Technical Service Bulletin

D71-21-6

TRANSMISSION

Valve Body
High Pressure
Relief Ball
Identification

STEEL BALL LOCATIONS

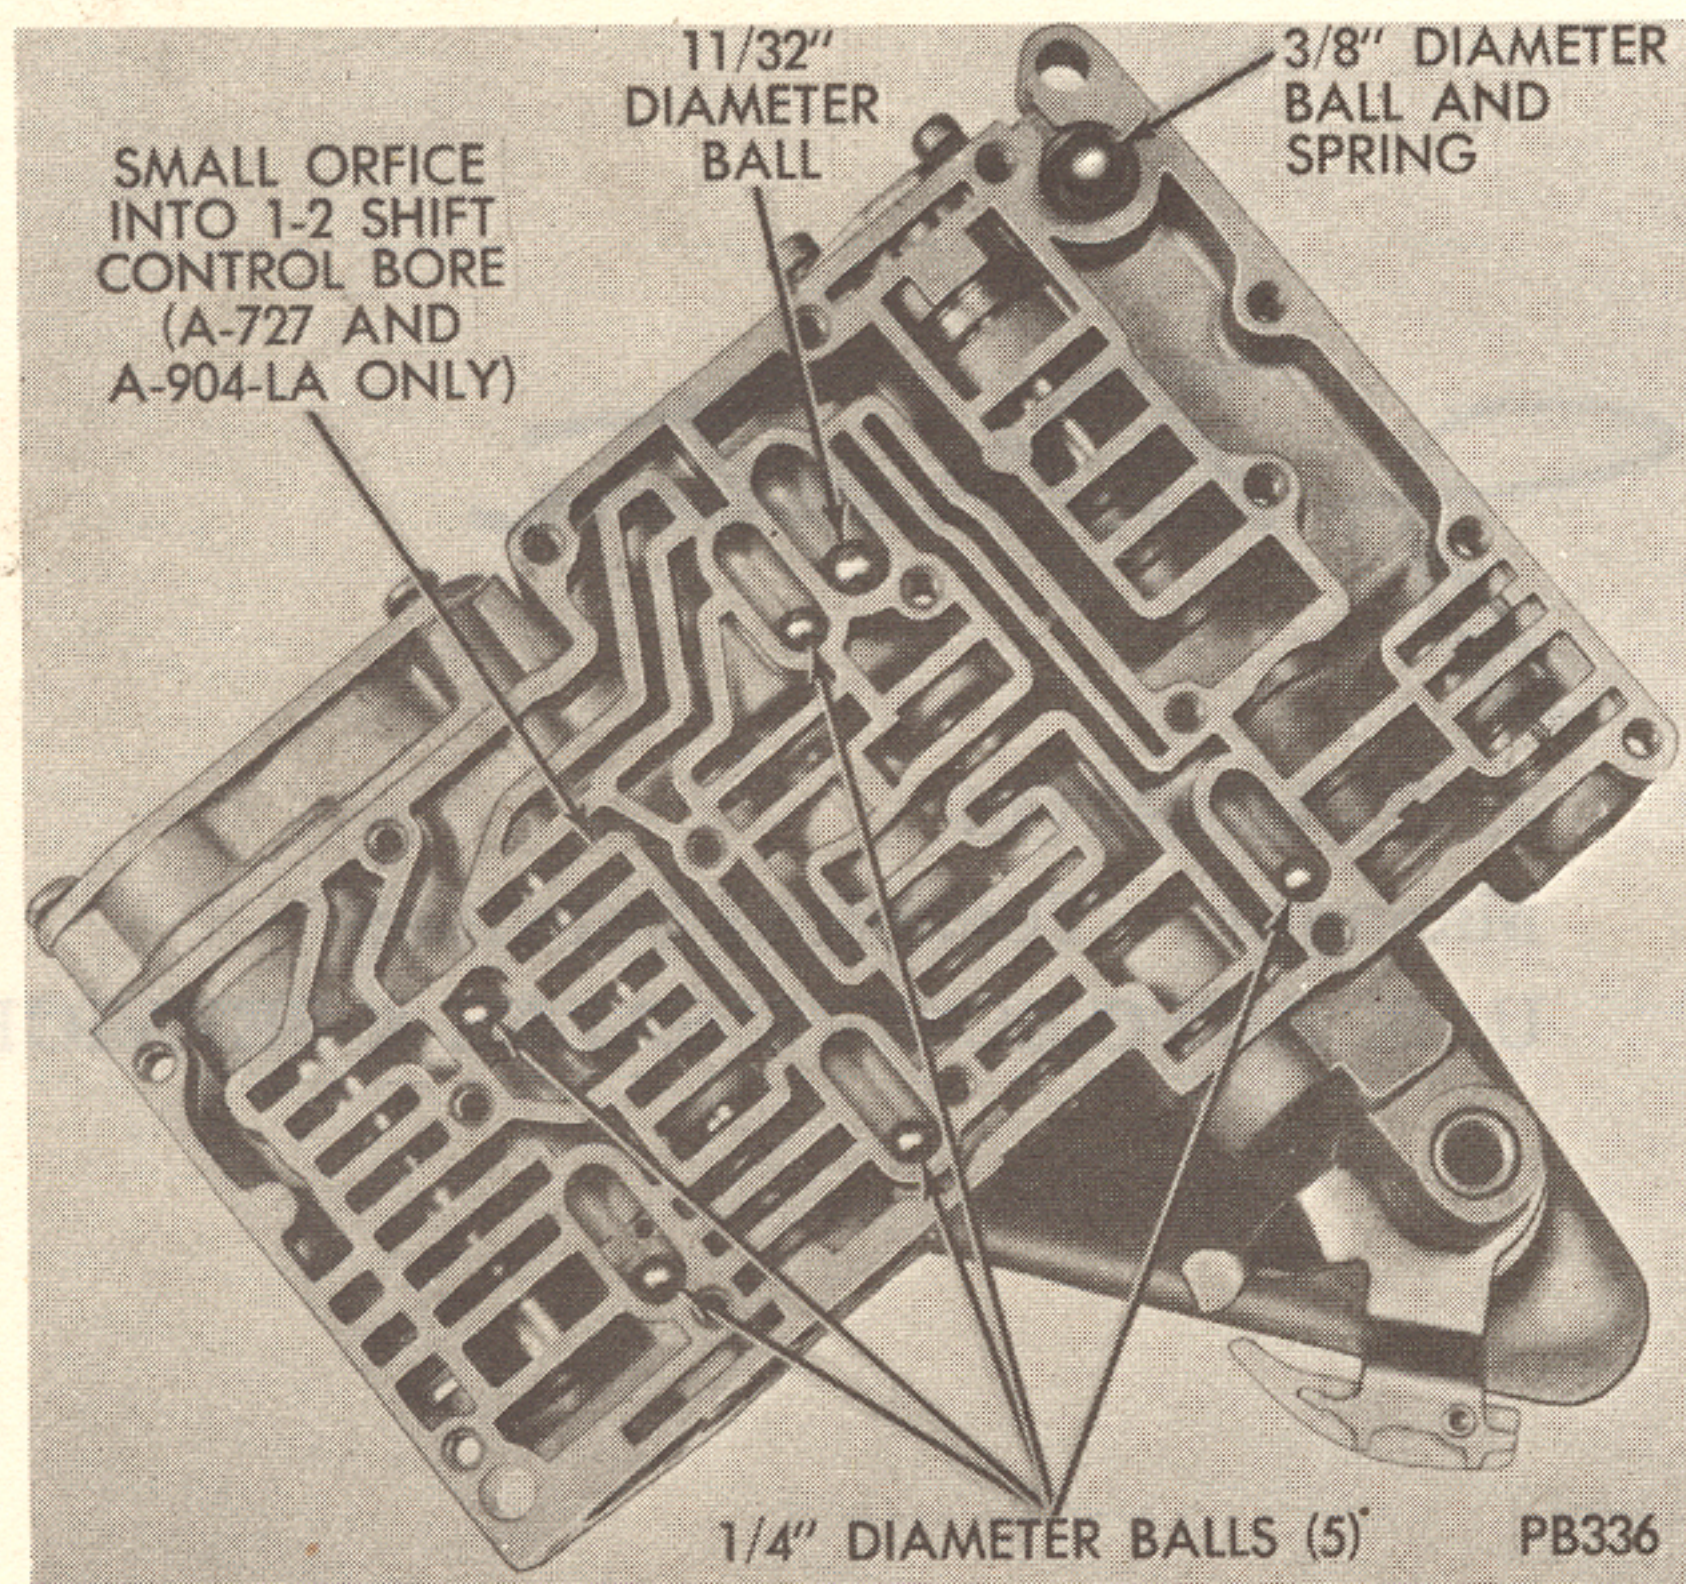
Early in the 1971 model year the high pressure relief ball (3/8 diameter) in the transmission valve body was changed from a "dull finish" to a "bright finish" to improve its seating ability. At the same time the number 3 check ball (11/32 diameter) was changed from a bright finish to a dull copper finish to prevent it from being interchanged with the high pressure relief ball.

The balls must be assembled as shown in the picture and chart. (No high pressure relief ball was used up to 1968.)

Interchanging the balls will cause excessive leakage in the front clutch circuit at the Number 3 check ball, and may cause high pressure relief ball not to seat properly.
